IB153

Tech Tips

FOR APPLICATIONS SHOWN BELOW

1989 Nissan Maxima

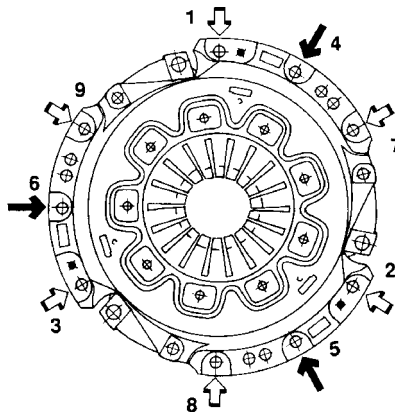
Some earlier models were originally equipped with only six mounting holes.

There has been a production upgrade to a nine hole unit.

The nine hole cover assembly in this set will work even if your flywheel only has six holes. See Torque Specs

1991-92 Infiniti G20

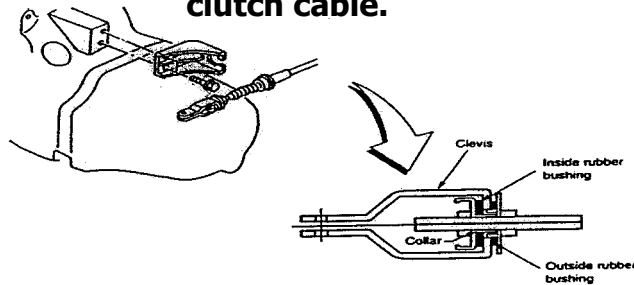
Infiniti models produced prior to 1992 Vin Number "JNKCP01D4PT455466" may require a clutch cable replacement. Premature wear, difficult shifting and noise are symptoms of a worn clutch cable.

Check the clutch cable end at the transmission for worn or out of position rubber bushings. If there are signs of wear, the cable should be replaced with an upgraded design that came out in 1993. The part number is 30770-62J10.
